## **Architectural Review Board Staff Report**

**Project Type:** Amended Site Development Section Plan

**Description:** **Kramer Commerce Center, Lot 2 (Cambridge Engineering)**: An Amended Site Development Section Plan, Landscape Plan, Architectural Elevations and Architect's Statement of Design for an 8.44-acre tract of land zoned "PI" Planned Industrial District located south of Interstate 64/Highway 40 and west of Long Road.

Figure 2: Architectural Site Plan

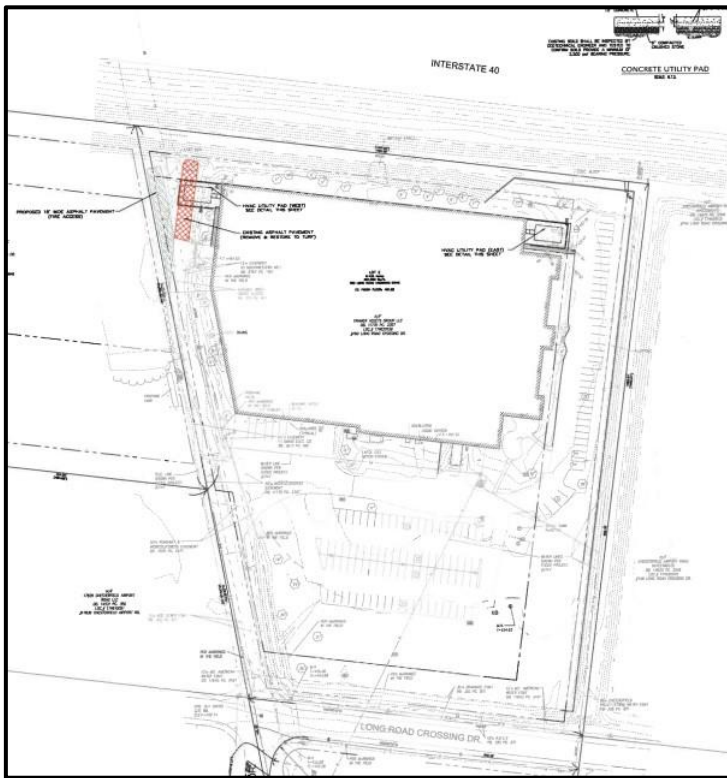
The subject site is served by one access point on Long Road Crossing Drive. The fire access lane on the west side of the building will need to be relocated to the west of the HVAC equipment pad and the applicant has submitted the ASDSP to Monarch Fire District for review.

Figure 5: Wall Enclosure

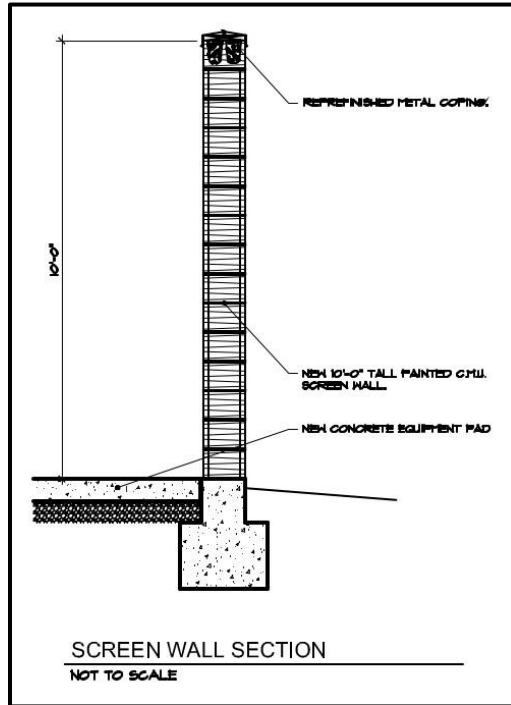
The HVAC enclosure will be comprised of concrete masonry unit block walls and painted to match the existing warehouse building.

Figure 6: North Wall Elevation

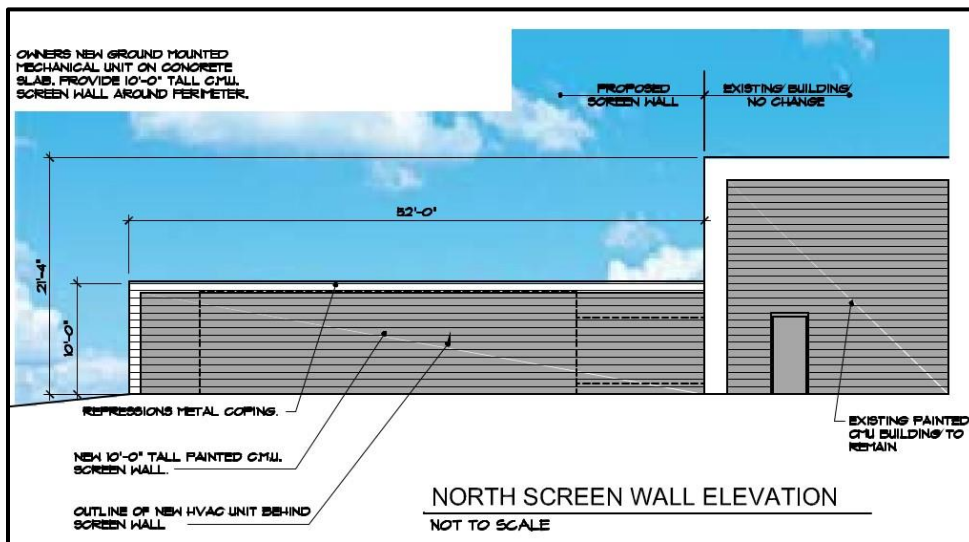
The masonry unit blocks are primarily earth tone in color, similar to nearby buildings which also utilize earth tone colors and concrete facades.
